# ARCHITECTURAL ADVISORY COMMITTEE MEMORANDUM

DATE: APRIL 5, 2021

SUBJECT: GRIT DEVELOPMENT, FOR A MINOR ARCHITECTURAL APPLICATION FOR THE CONSTRUCTION OF A NEW SEVEN (7') FOOT TALL WALL TO ENCLOSE AN EXISTING COURTYARD FOR THE CONSTRUCTION OF A POOL AREA AS PART OF AN ADAPTIVE REUSE OF AN OFFICE/RETAIL BUILDING TO A SUITE HOTEL LOCATED AT 125 EAST TAHQUITZ CANYON WAY, ZONE CBD, SECTION 15 (CASE 3.2148 MAA) (GM)

5.0 POOL WALL - TILES TO MATCH DOME

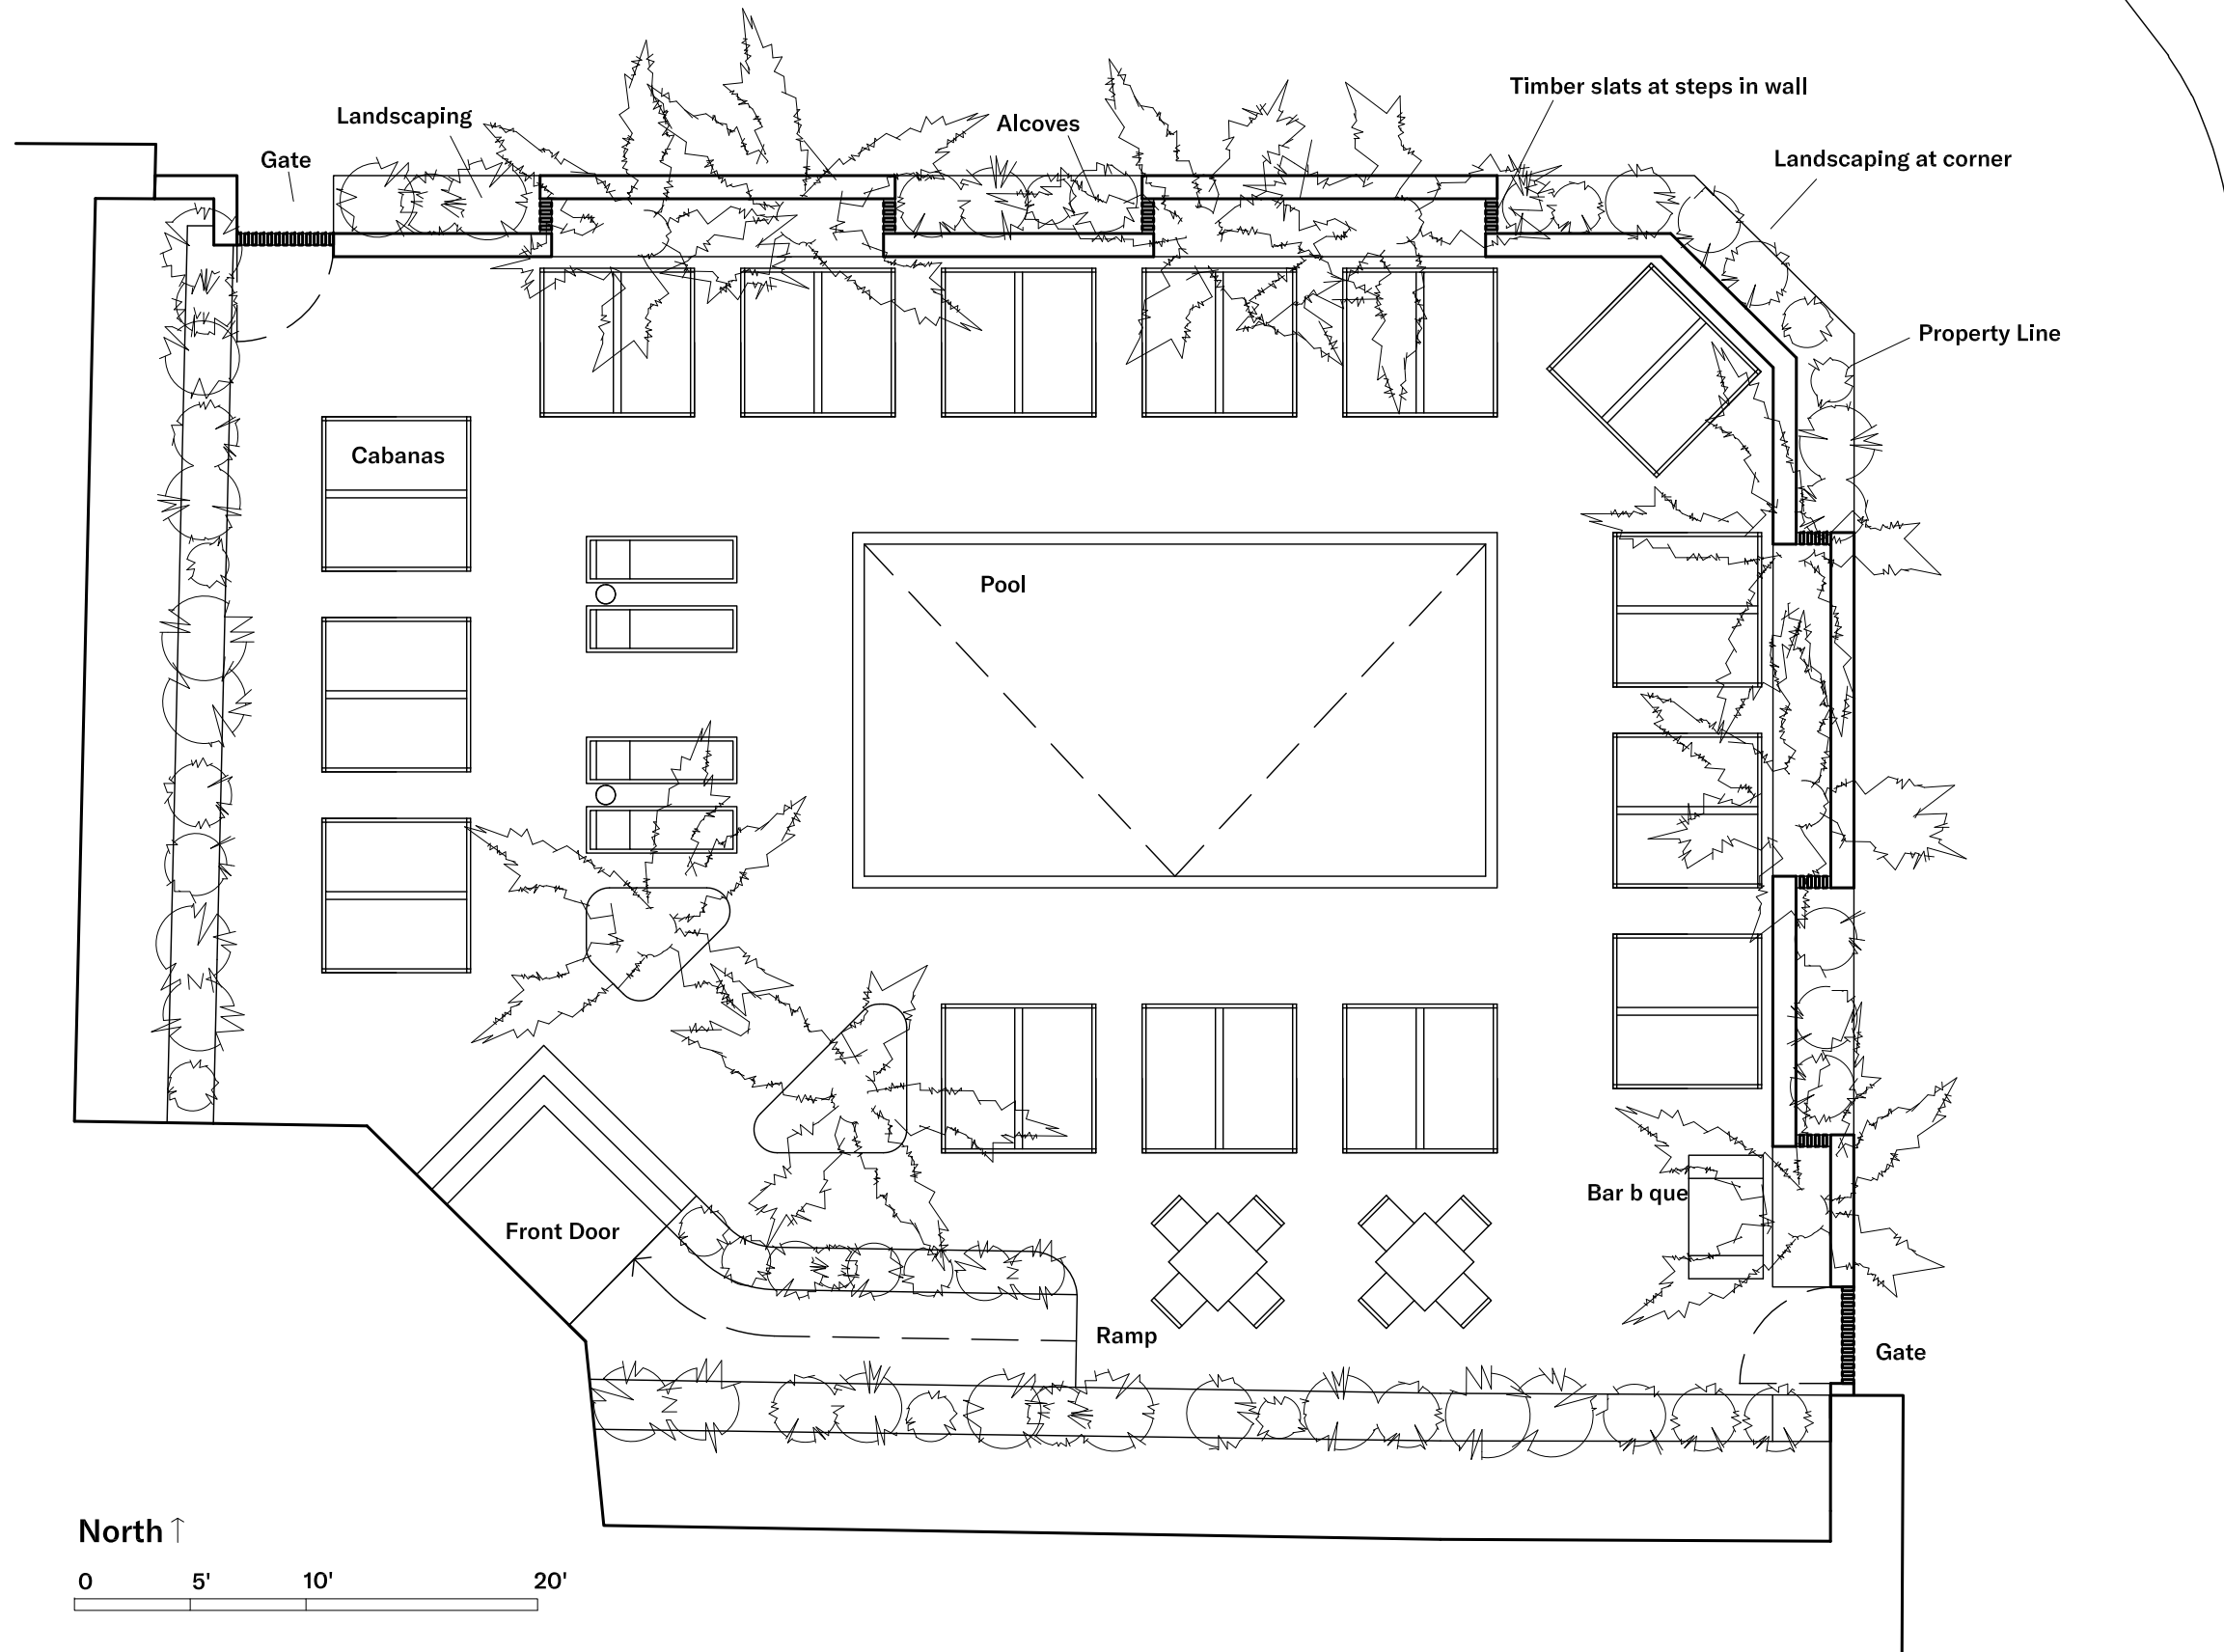
This version of the wall provides depth, areas of light and air circulation, and a more appealing façade for the pedestrian by using wooden slats which off-set the block walls by 2'-6". The street side wall will be clad in triangular tiles in colors found on the building dome tying the two together. The graphic pattern of the tiles is a design feature that can be incorporated into the street facing wall. The wall is stepped in plan to create alcoves on the street side. These alcoves will be landscaped to bring a pedestrian scale to the wall. Breaks in the wall are located at the steps with wood slats creating discrete views in and out of the pool area. The corner is set back so that landscaping can be introduced as well as planter areas along both street frontages.

Guidelines [PSZC 94.04.00(D)]	Compliance
2.	<p><i>Harmonious relationship with existing and proposed adjoining developments and in the context of the immediate neighborhood/community, avoiding both excessive variety and monotonous repetition, but allowing similarity of style, if warranted;</i></p> <p>The Plaza Las Flores building is Spanish Colonial style with unique features such as arches, heavy stucco, wood, masonry, large glass windows, and ironwork. The proposed options use one element currently on the building (tiles from the dome, and clay roof tiles) however the hard edge of the walls at the sidewalk is not pedestrian friendly or engages with the street. The wall alcoves and wooden slats provide some relief to the length of the wall, however additional detailing is needed.</p>	No

3.	<p><i>Maximum height, area, setbacks and overall mass, as well as parts of any structure (buildings, walls, screens, towers or signs) and effective concealment of all mechanical equipment;</i></p> <p>The proposed wall height is seven (7') feet located at the property line. The PSZC allows a wall of this height in the CBD zone, however Staff believes that an alternative design that engages the street and is inviting to the pedestrian would be more consistent with the Downtown Design Guidelines.</p>	No

1. Wall to meet the intent of the Downtown Urban Design Plan.
2. Lower wall to six (6') feet.
3. Add planter areas at base of wall to soften the hard sidewalk edge as it meets the vertical wall.

### 5.8 POOL WALL - ROOF TILES

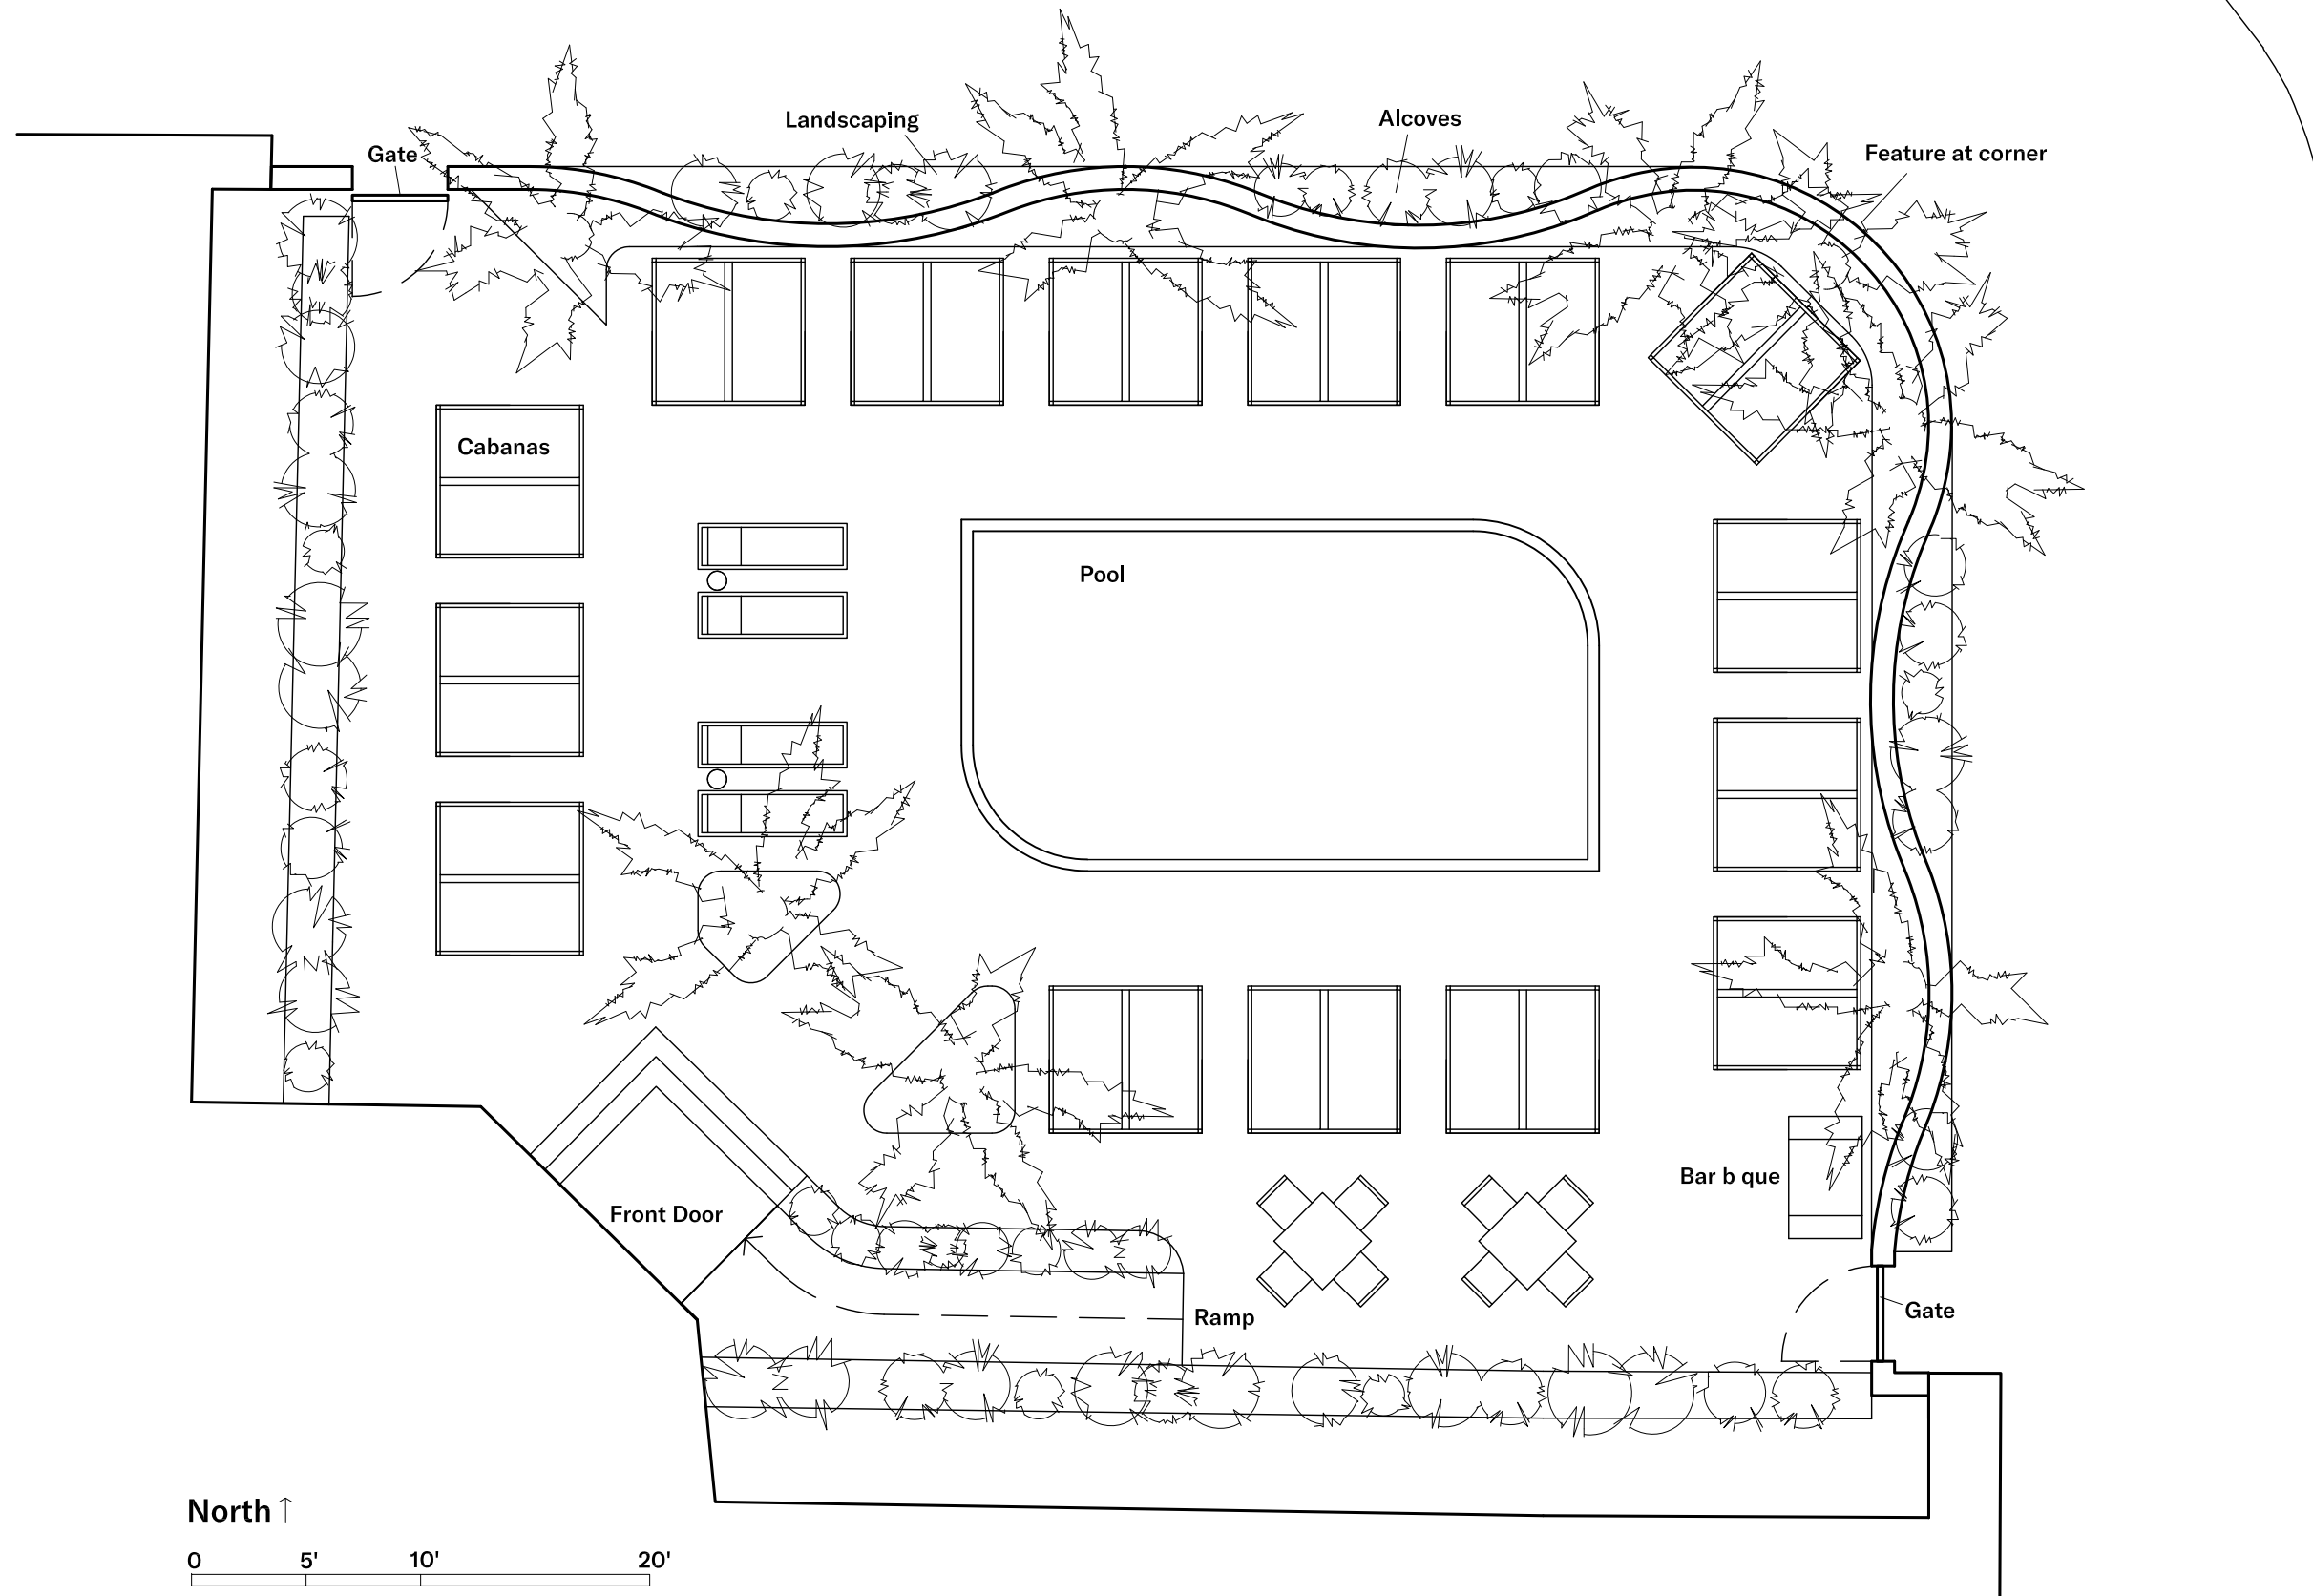
The second option is to use clay roof tiles as the primary material in the wall design and structure. Plaza Las Flores roof is distinctive and adds a rich texture to the building's appearance. The wall constructed of the clay tiles references the buildings Spanish Colonial style but also the numerous breeze block walls that are used in the City. This proposal is to use a concrete base and infill areas with the clay tiles open at the top. The wall height will be seven (7') feet and undulate along the street frontages allowing for alcoves and landscaping.

The enclosed courtyard will have a swimming pool and deck for lounge chairs and several cabanas. The plantings proposed include five (5) Kumquat trees, Pigmy Date Palms, California Fan Palms, multiple Natal Plum and Flax Lily plus various vines. The alcoves on the street side of the wall are not defined on the applicant's submission. Staff believes that additional setback is needed to provide for landscaping on the street side.
